ADDENDUM No. 1

South City Campus – Fire Alarm Upgrade

DFCM Project No. 08074670

Subject: Revisions to Fire Alarm Drawings for Addendum 1

Sheet FA-19:

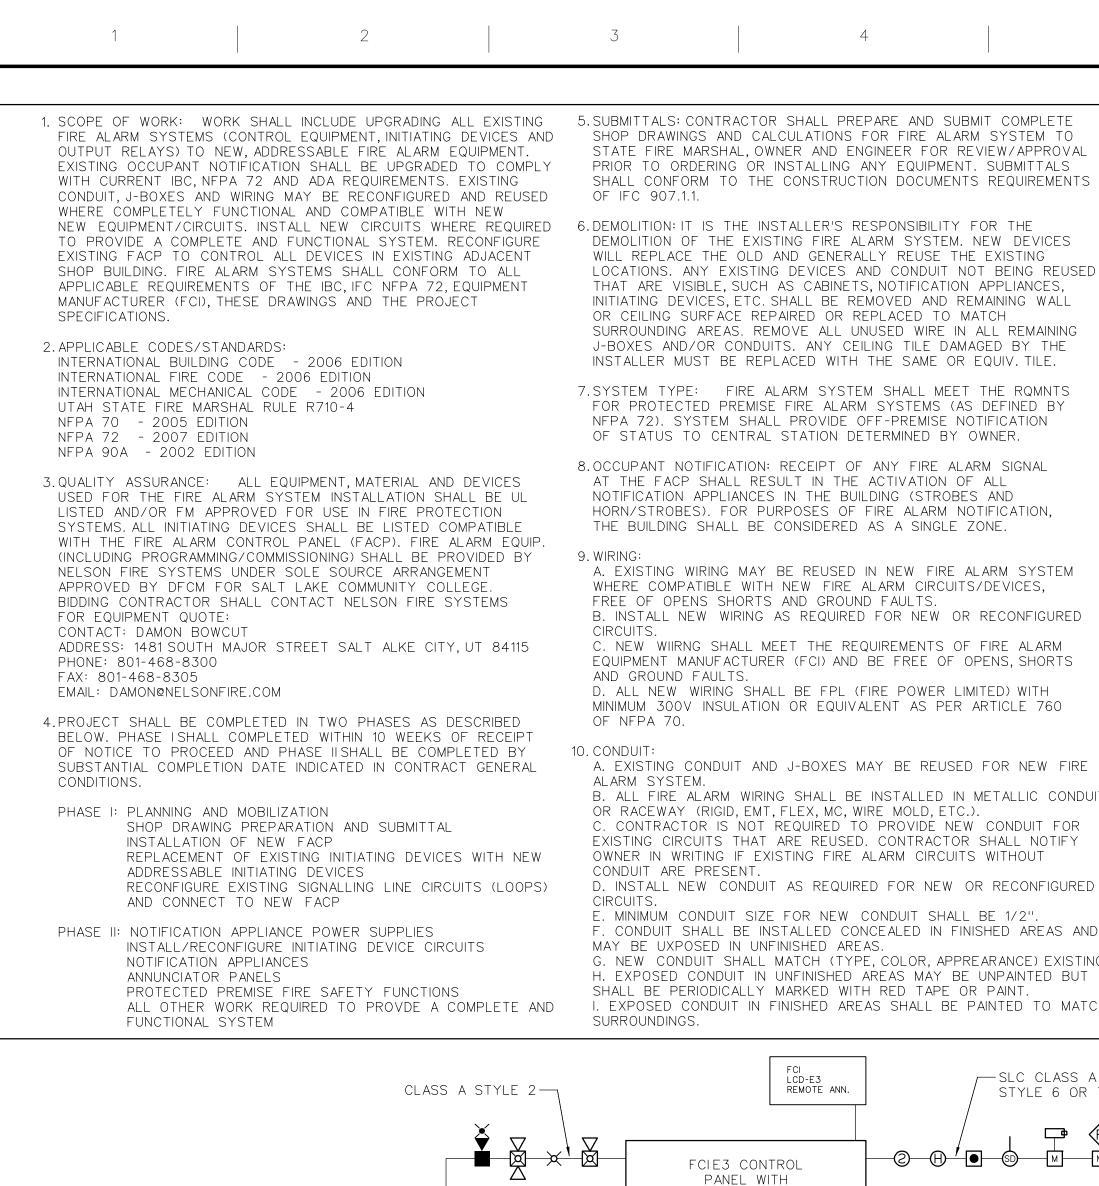
3. Updated legend and added a key note to describe the remote test stations for the duct smoke detectors

INSTALL NEW FCILVD-E3 REMOTE ANNUNCIATOR PANEL ADJACENT OT PULL STATION AT MAIN BUILDING ENTRY. ANNUNCIATOR MAY BE SURFACE MOUNTED BUT ALL CONDUIT SHALL BE CONCEALED IN WALL. PROVIDE NEW CIRCUIT (MINUMUM OF 4 INSTALL REMOTE TEST STATION (FCIRTS451KEY) FOR EACH DUCT MOUNTED SMOKE DETECTOR LOCATED IN AN INACCESSIBLE LOCATION ABOVE THRID FLOOR CEILING. LOCATE TEST STATION WHERE INDICATED ON PLAN OR ALTERNATE LOCATION PROPOSED BY CONTRACTOR AND APPROVED BY ENGINEER. CONNECT TEST STATION TO DUCT SMOKE DETECTOR PER MANUFACTURER'S RECCOMMENDATIONS AND LABEL EACH TEST STATION WITH AIR HANDLER UNIT NUMBER AND DETECTOR ADDRESS.
